ROGERS PLANNING COMMISSION

May 6, 2024 - 7:00 PM

Subject: Site Plan Request for an Addition to the Ellingson Motors Building at 20950 Rogers Dr

Prepared By: Alec Henderson, City Planner

SITE PLAN

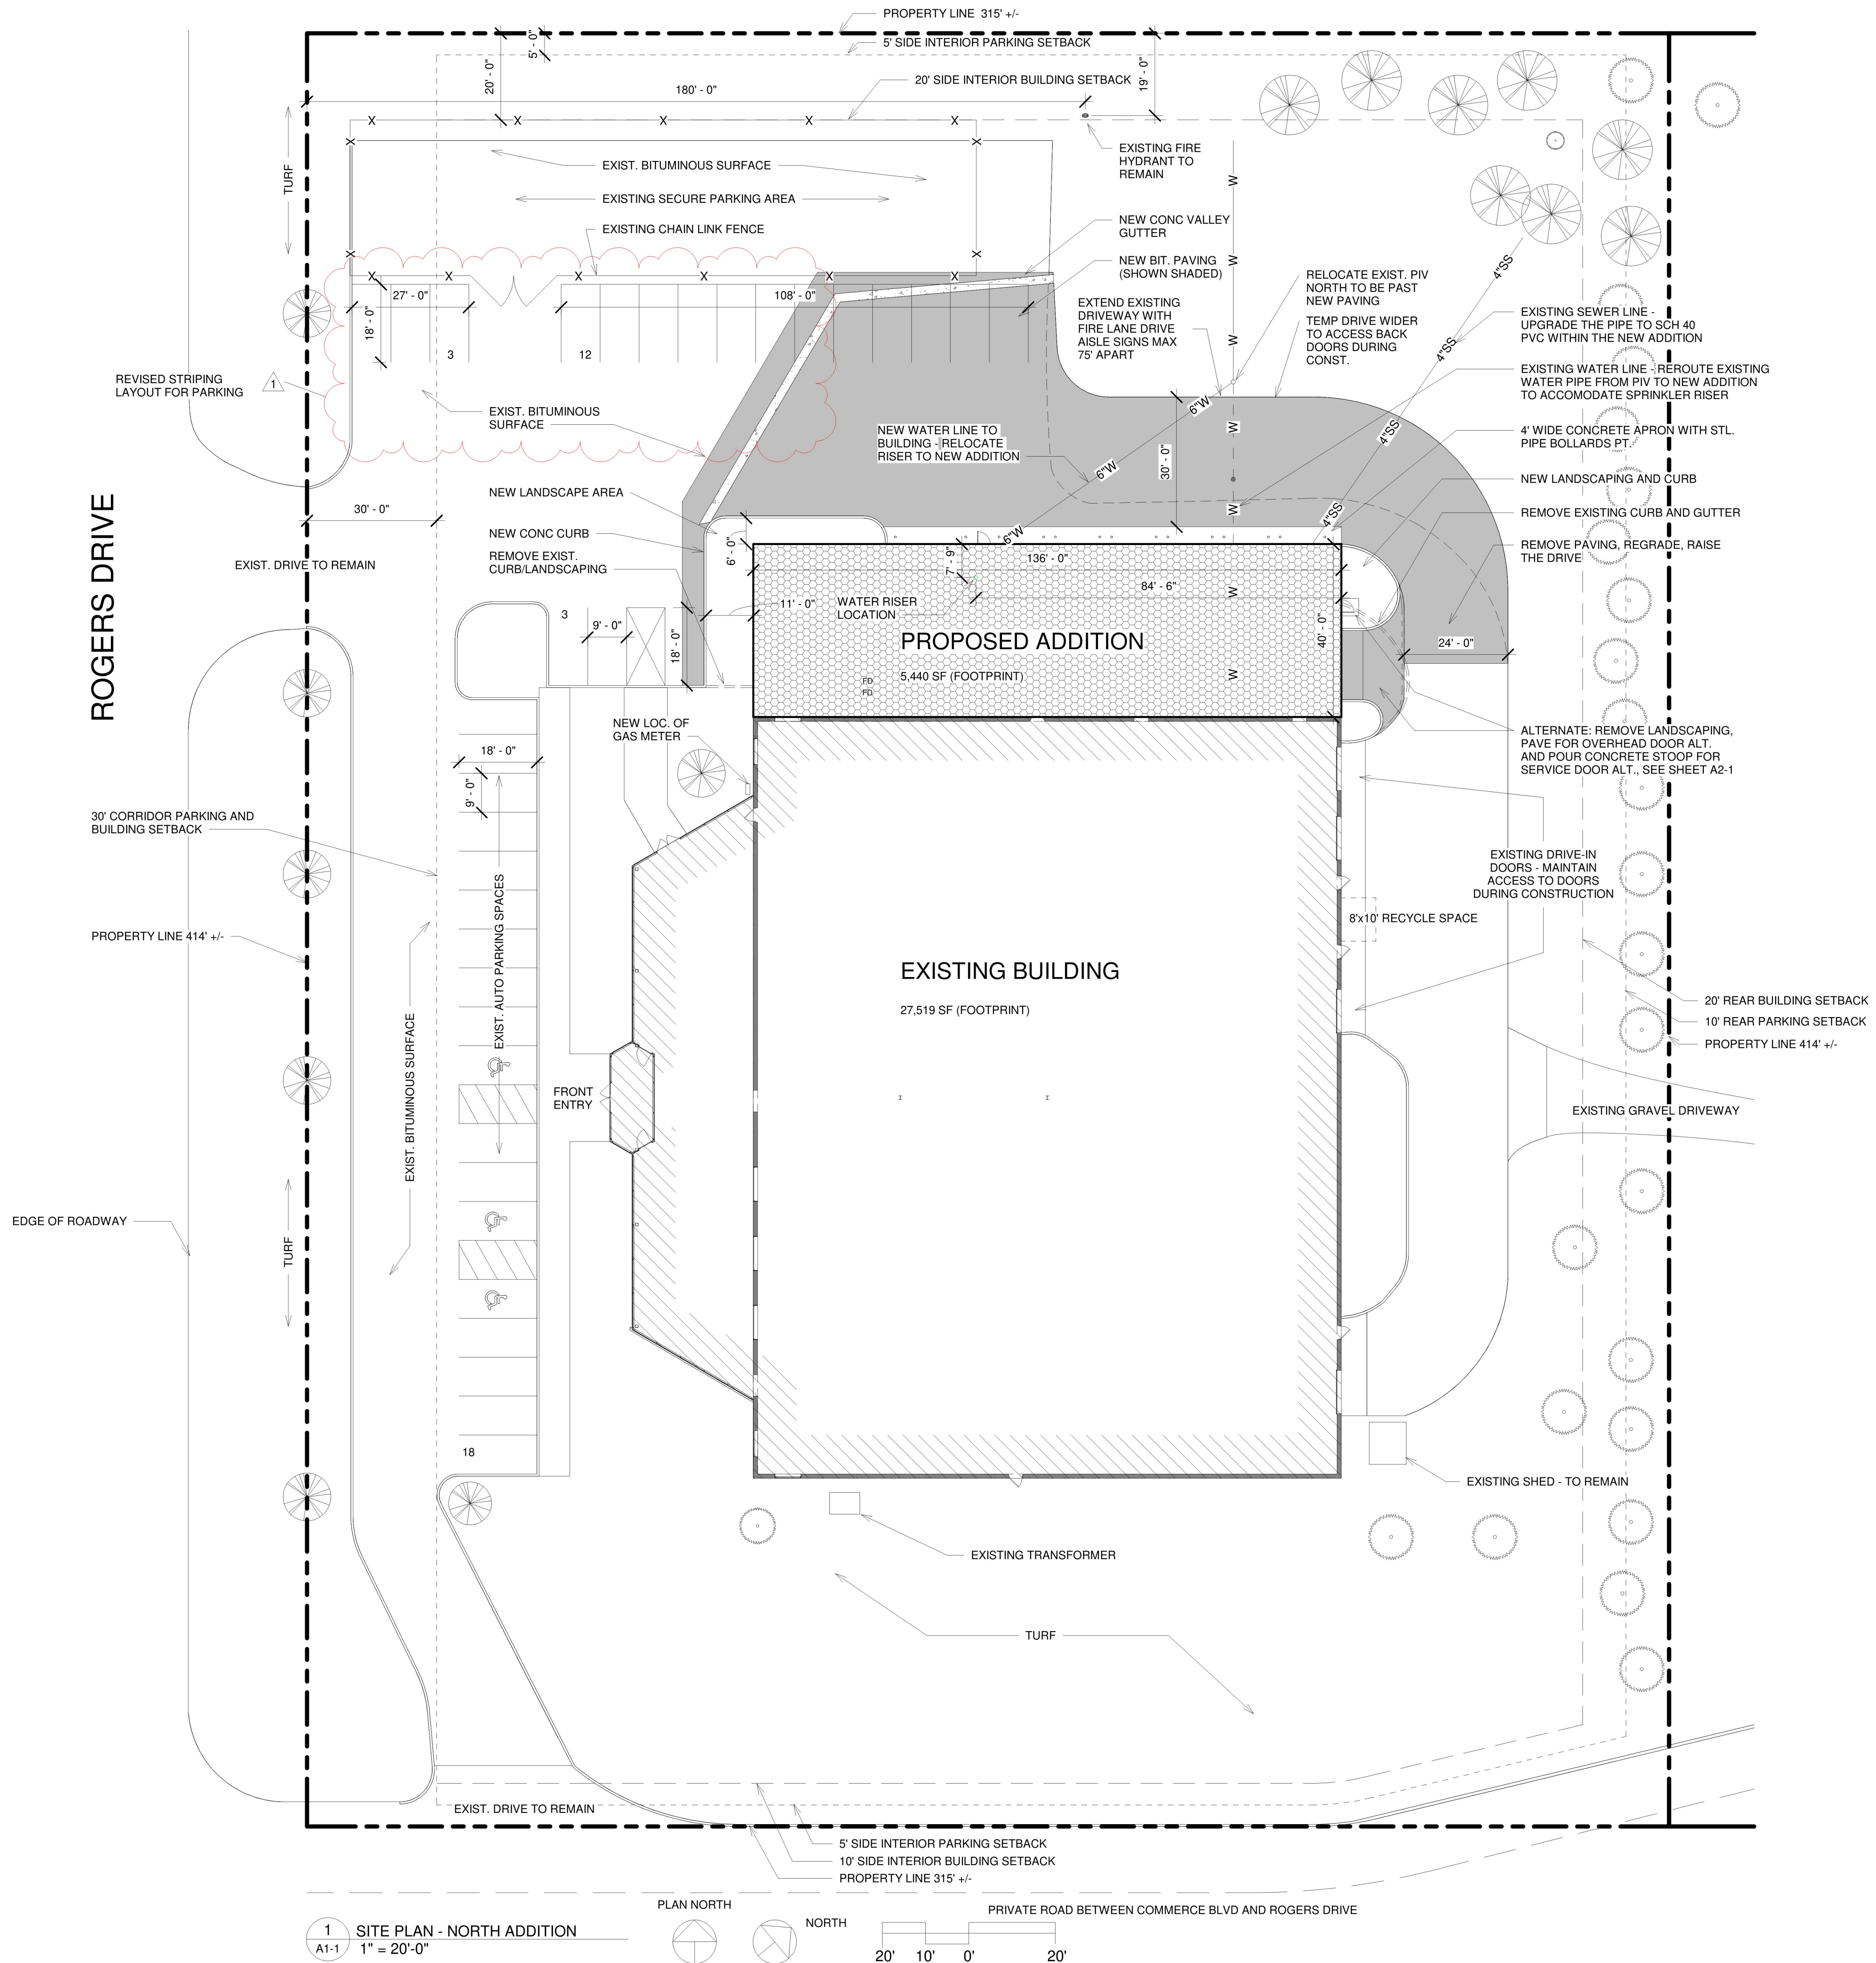
The addition will add 5,440 square feet to the building for a total of 35,997 square feet. The addition will also necessitate a slight shift in the drive lane on the west/northwest side of the building. All together with the existing parking lot, revised drive lane, addition rear building access and building addition, the impervious surface is roughly 56% which is under the 75% RC district max, and Corridor Overlay max of 65%. The disturbance is under watershed review thresholds, but our engineering department has reviewed the grading and civil plans.

Parking required for the use is approximately 56 spaces. 36 spaces are currently shown, with the fence/secured parking (totaling 20 spaces) shown as proof or deferred. With low customer visits, the owner does not see parking issues with the shown parking plan, but notes that there is space for additional parking should it be necessary. Fire suppression is planned for the building.

1. All engineering comments shall be satisfied prior to construction.
2. Any necessary Elm Creek Watershed Permitting and Requirements shall be met prior to construction.
3. SAC Determination shall be submitted to the Metropolitan Council and all building and connection fees paid prior to issuance of the building permit.
4. Any future addition will also require future site plan approval as required by section 125-27.
5. If parking demands warrant, the fenced area/proof of parking shall be converted to striped parking stalls necessary to handle additional parking as determined by Staff and Parking Code requirements.
